**MUNICIPAL CORPORATION
KARACHI.**

PLAN SHOWING PROPOSED TOP FLOOR ON PLOT NO 54 & 55
SHEET M.M.6. MACHHIMIANI QUARTER.
SCALE 8"=1"

Re:~ Plot No. 54 & 55 M.M.6

Case No: B. S.

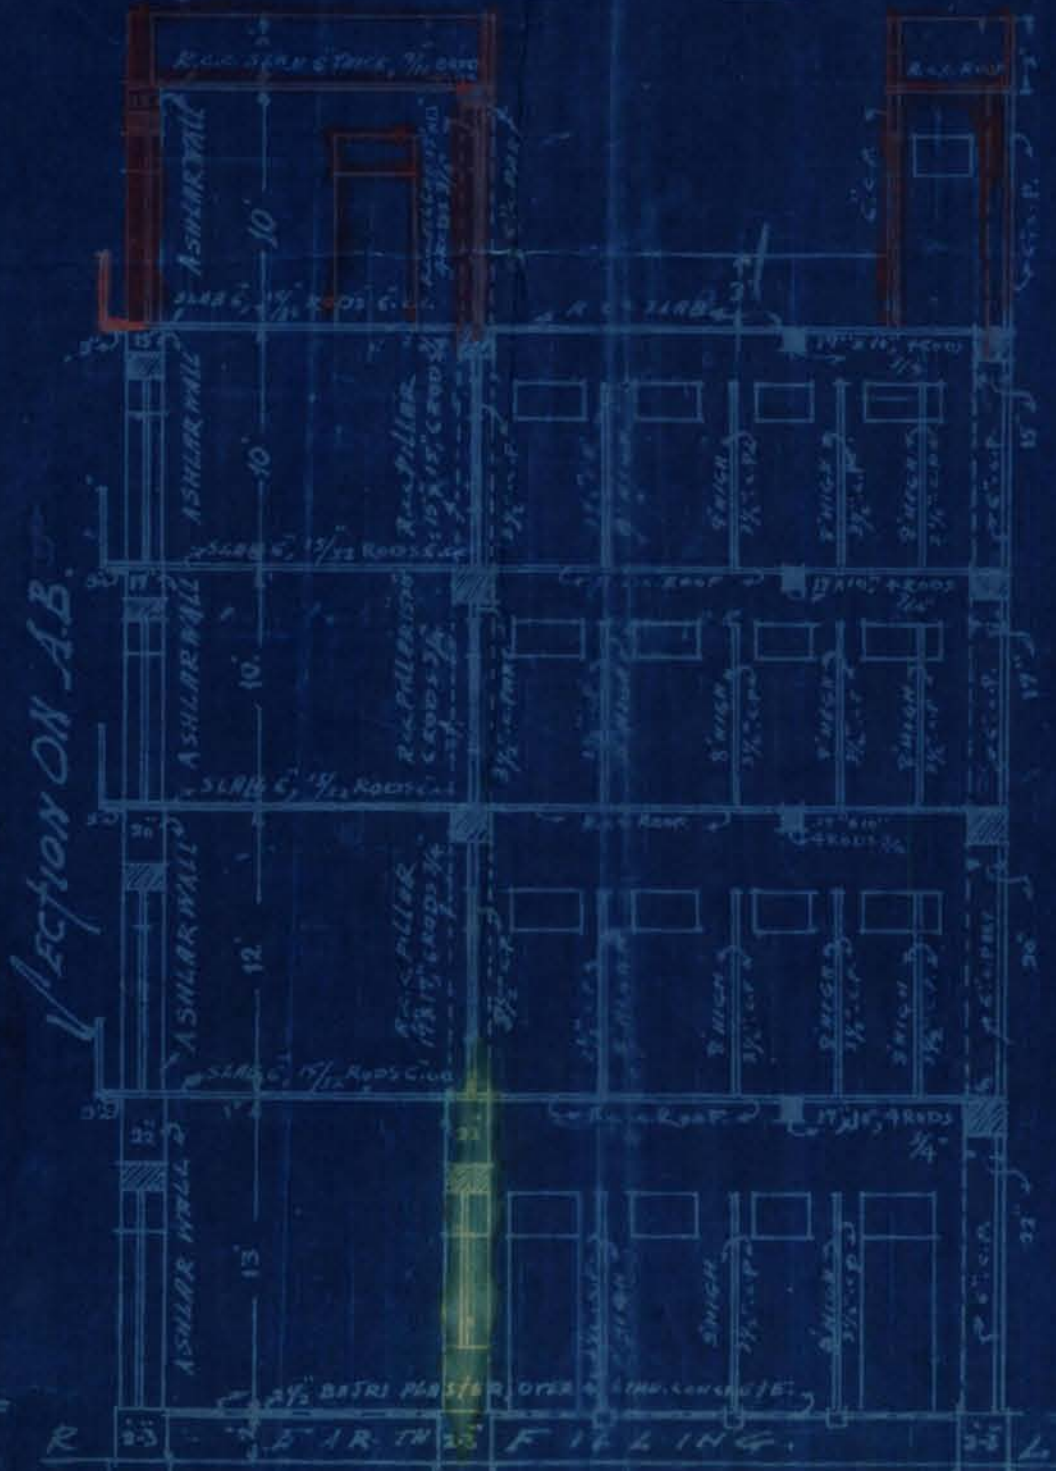
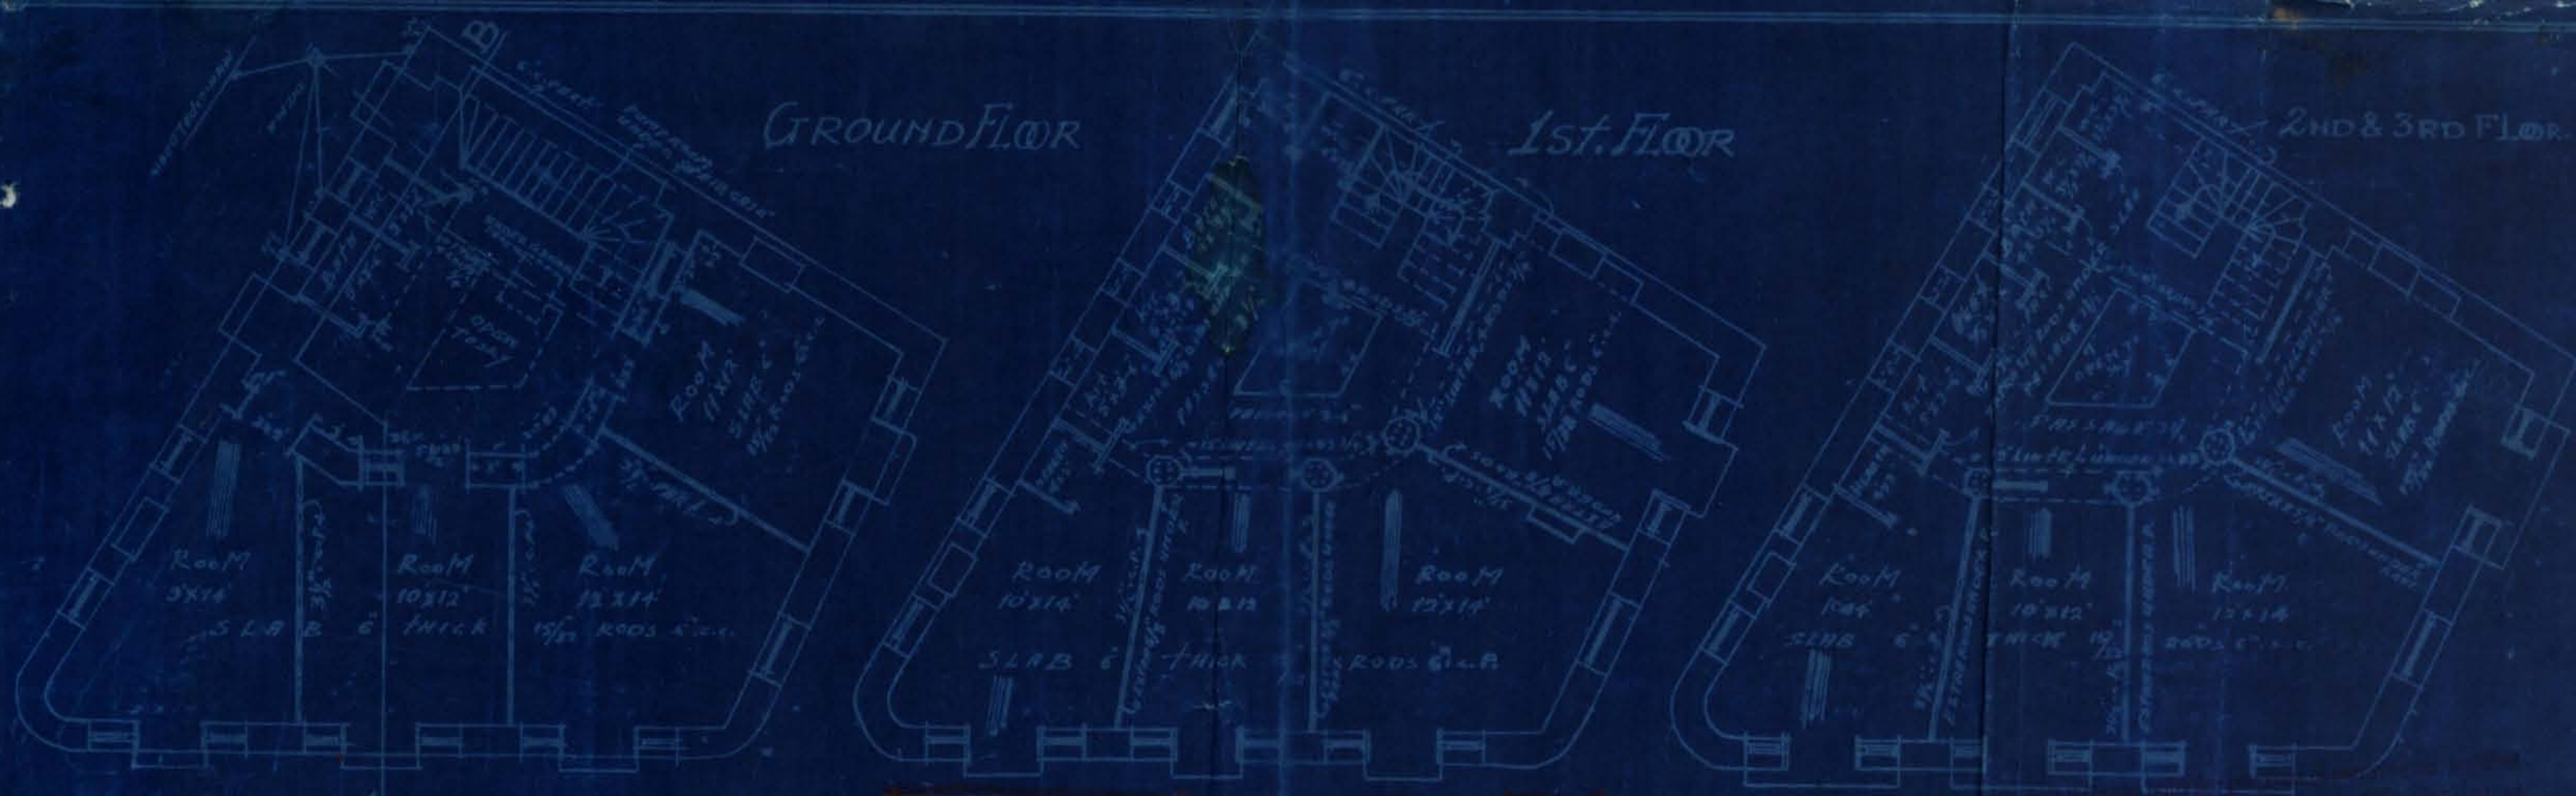
As regards the Bldg. on the ~~form~~ plan, the present plan is only for an additional story, the existing Bldg. consisting of 2 ft + 3 upper stories. The thickness of walls is shown correctly by the architect and is more than that is contemplated in our by-laws for cut-stone masonry.

No other requirement therefore remains. The load as indicated comes to 8.23 T/ft². The masonry is dressed on ^{all} sides except the plastered side.

PLAN SHOWING PROPOSED TOP FLOOR
ON PLOT No 54 & 55. SHEET No. M.M. 6.
MACHHIMANI QUARTER
SCALE 8"=1"

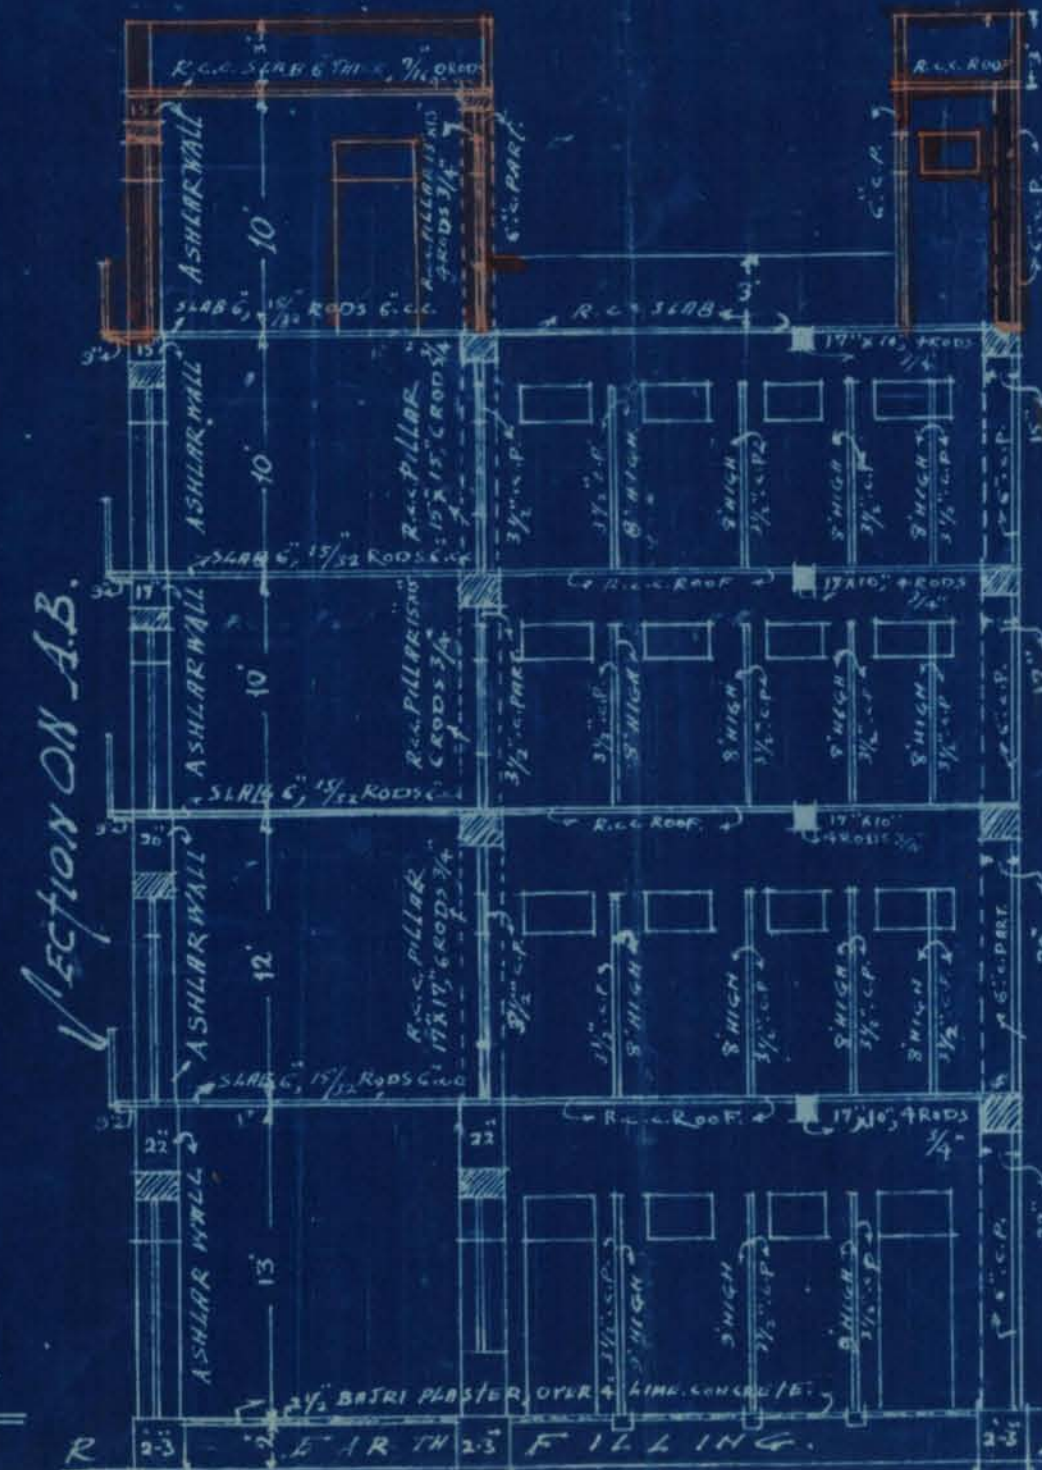
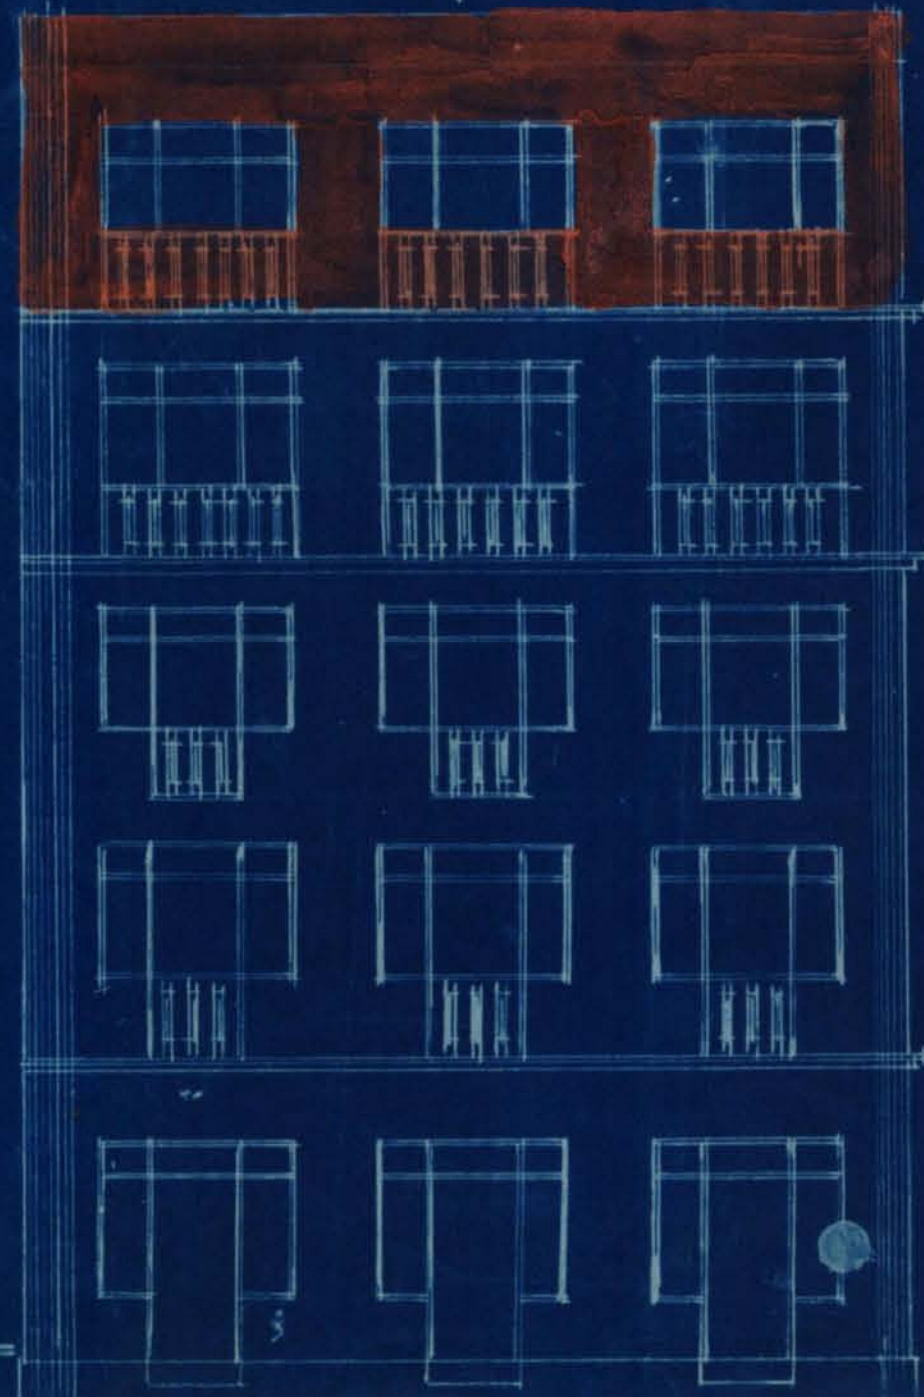
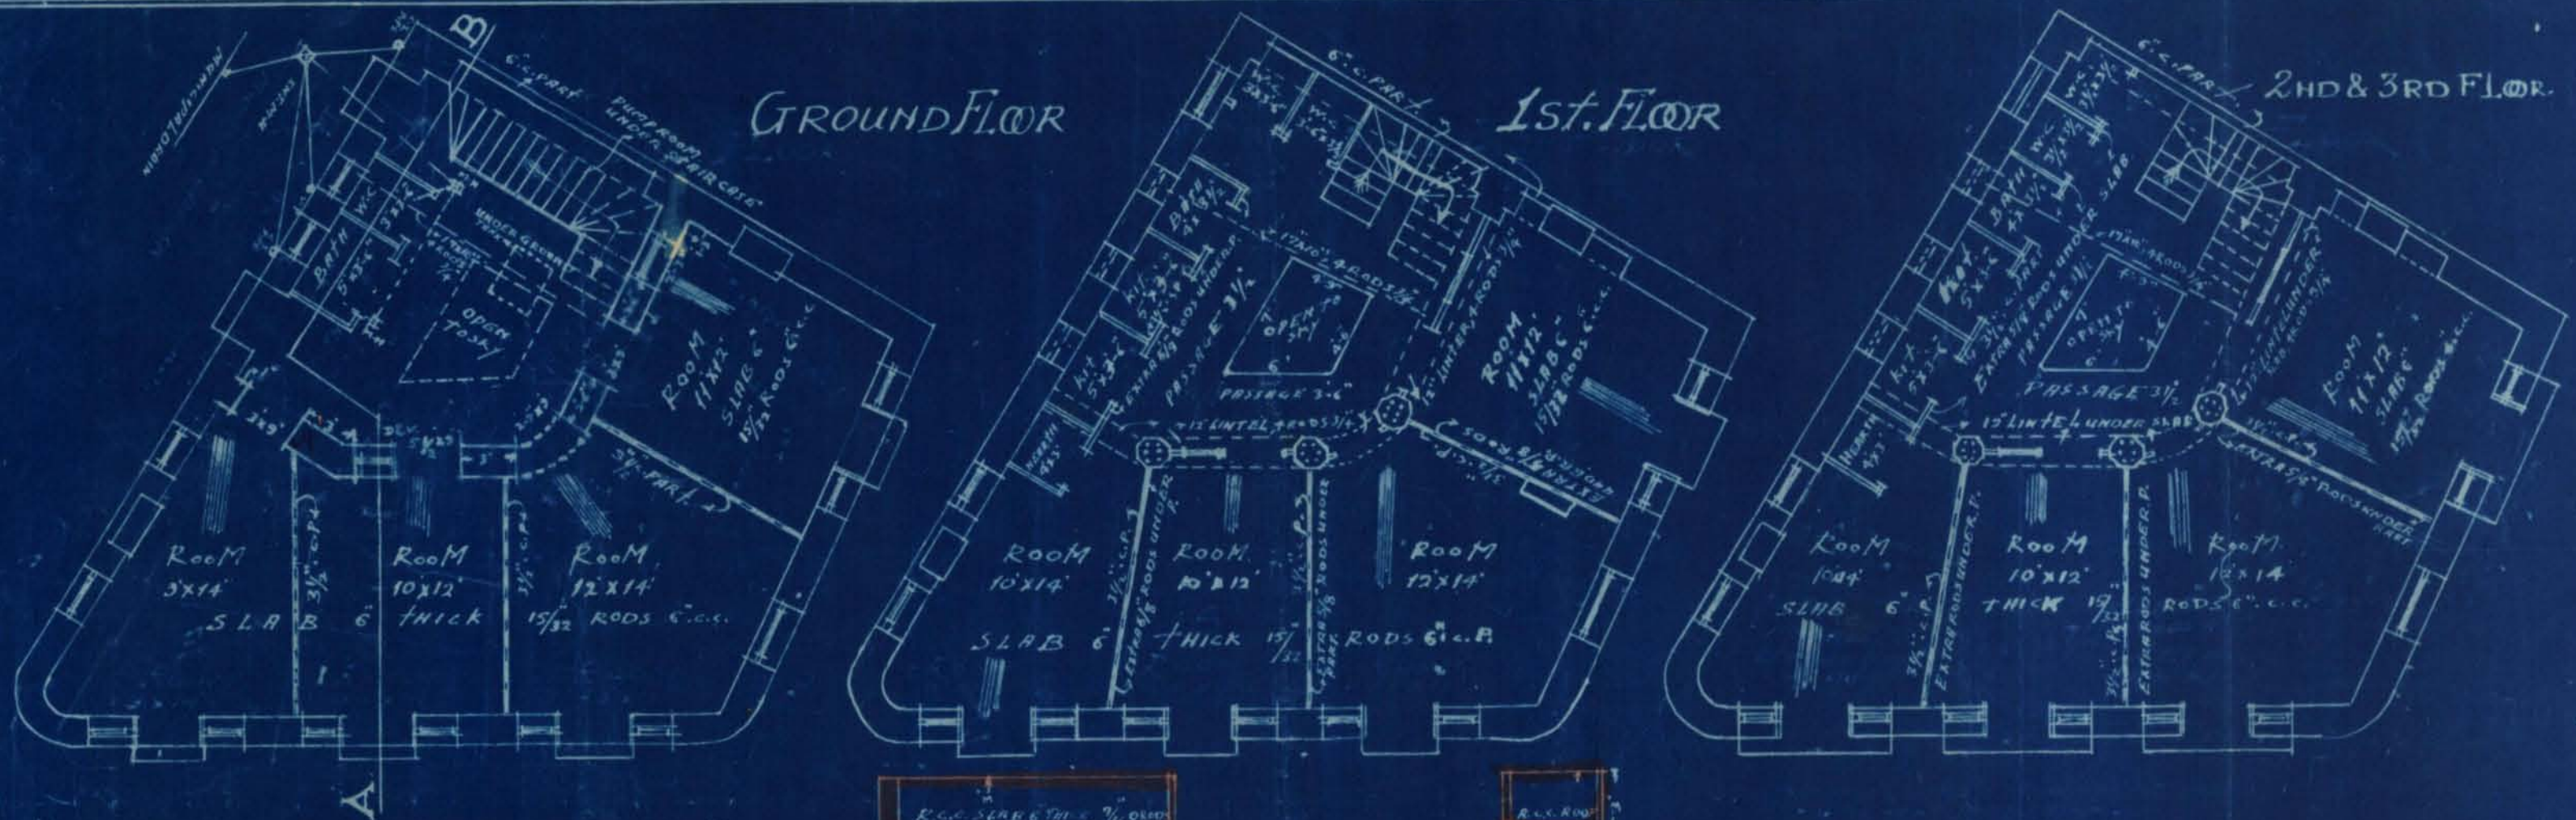
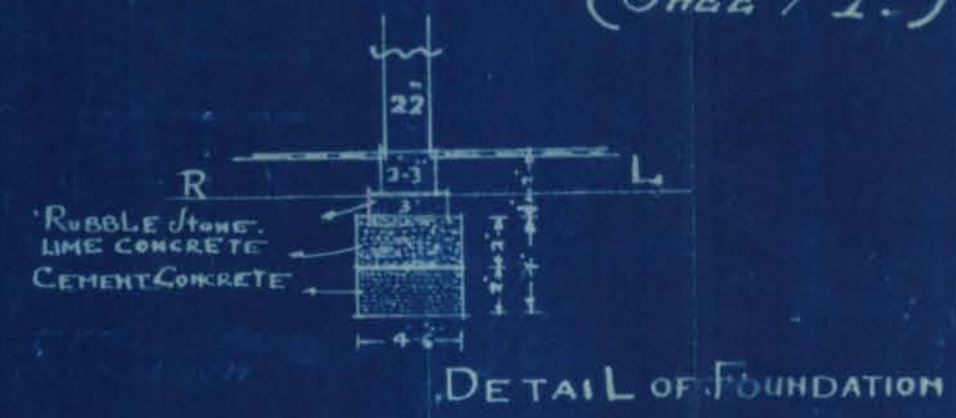
The thickness of walls shown in plan is more than that shown in original plan passed in 1929 & referred to in his letter of 29 June 38 and that the same is shown more than that on site. Height of structure is also not correctly shown.

One of the W.C.s on upper floor is against rule as it does not abut directly on open space.

The plans now show the existing structures on all floors correctly.

No.3 & 4. The thickness of walls shown in the plan is not more than shown in the amended approved plan. It has been shown as per site. Height is also correctly shown.

No.5. W.C. referred to is as per approved plan.

=SITE PLAN=

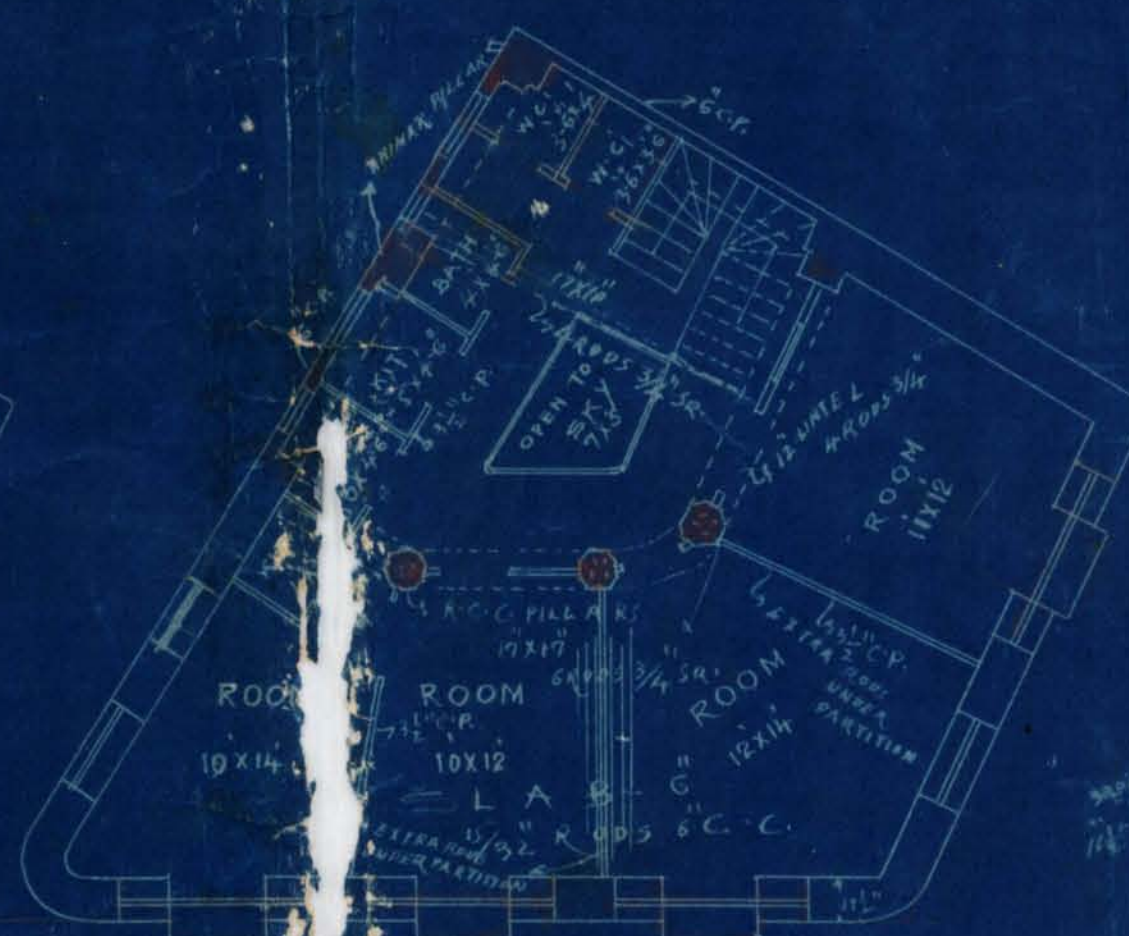
Site plan is wrong, plot nos 54x55 are separate plots & not amalgamated one as shown in the site plan.

(5) Site plan shows the measurements and area of both the plots No. 54 & 55 separately.
